Official Transcript of Proceedings
NUCLEAR REGULATORY COMMISSION

Title: Advisory Committee on Reactor Safeguards
Regulatory Policies and Practices

Date: Thursday, August 18, 2011

The Subcommittee will hear presentations from the NRC Staff regarding the new Staff Guidance for use in selecting the design basis hurricane wind speed and hurricane generated missiles that a new nuclear power plant should be designed to withstand, as discussed in the draft Reg Guide 1.221, Design Basis Hurricane and Hurricane Missiles for Nuclear Power Plants.

Holland B Parameter

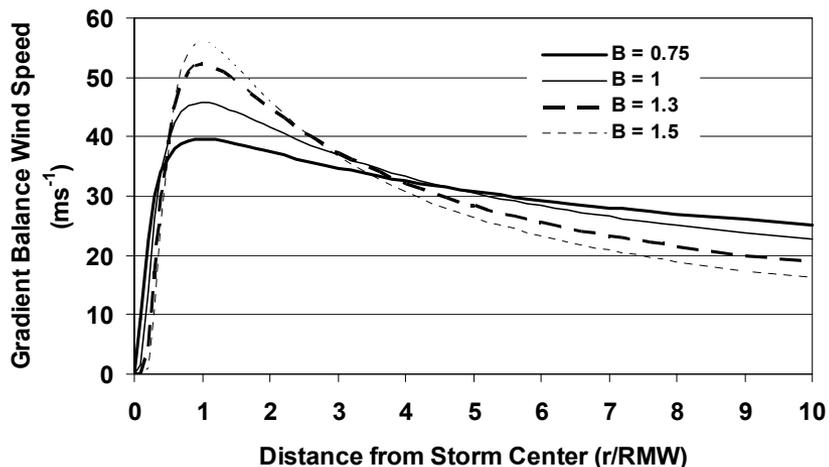
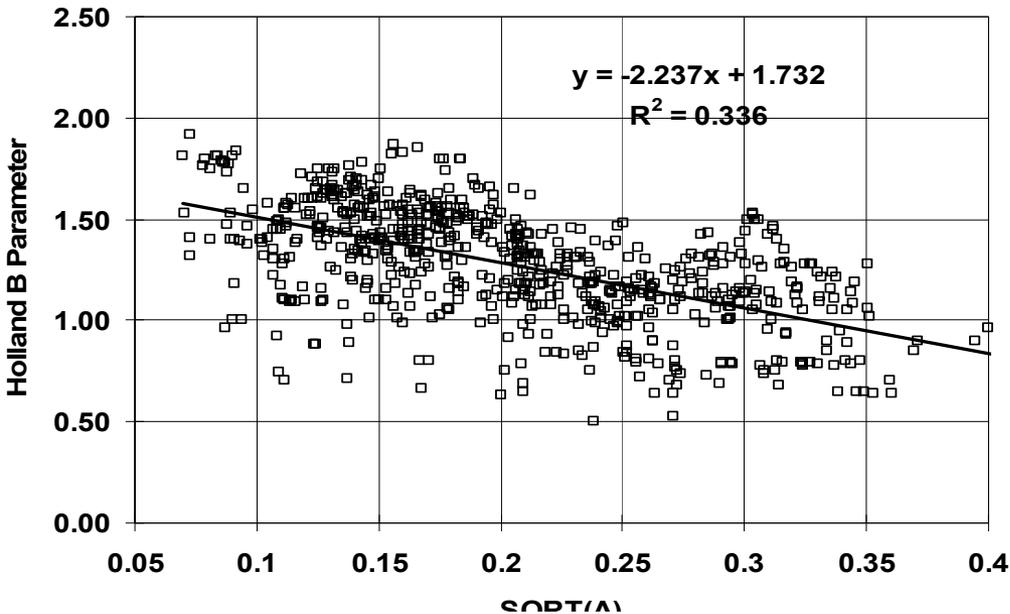
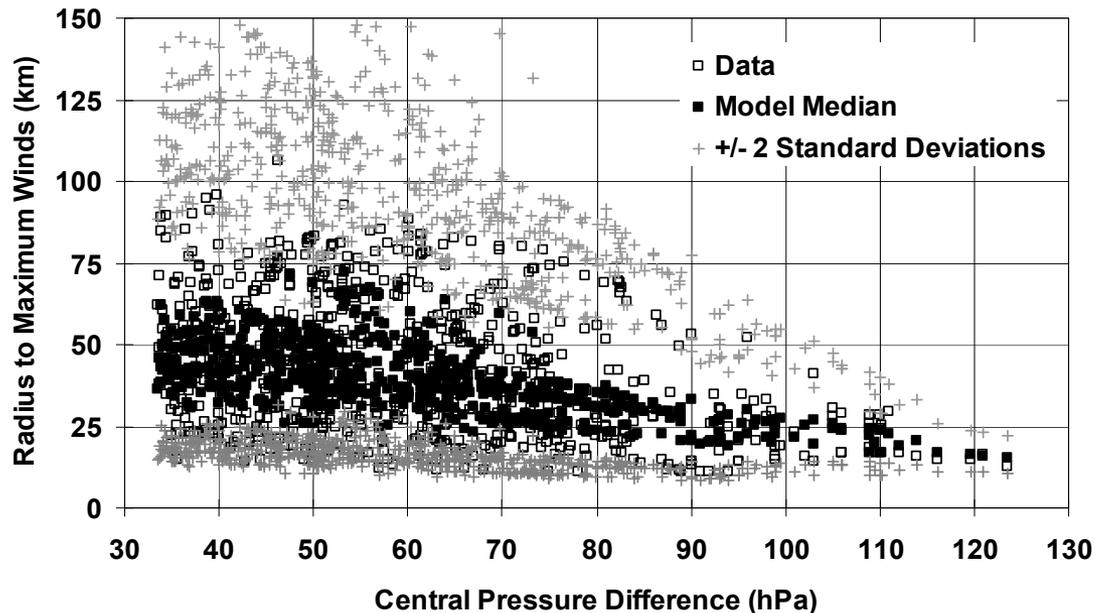
10 CHAIR SHACK: The Figure 2-7 in the NUREG
11 seems to have a different database for the B parameter
12 than you're showing here.

14 CHAIR SHACK: Yes, it's Figure 2-7. It's
15 referring back to the 2009 paper.

9 CHAIR SHACK: Well you need to put this
10 figure in.

13 CHAIR SHACK: I mean this figure looks
14 like what I'd expect to see in a regression fit.
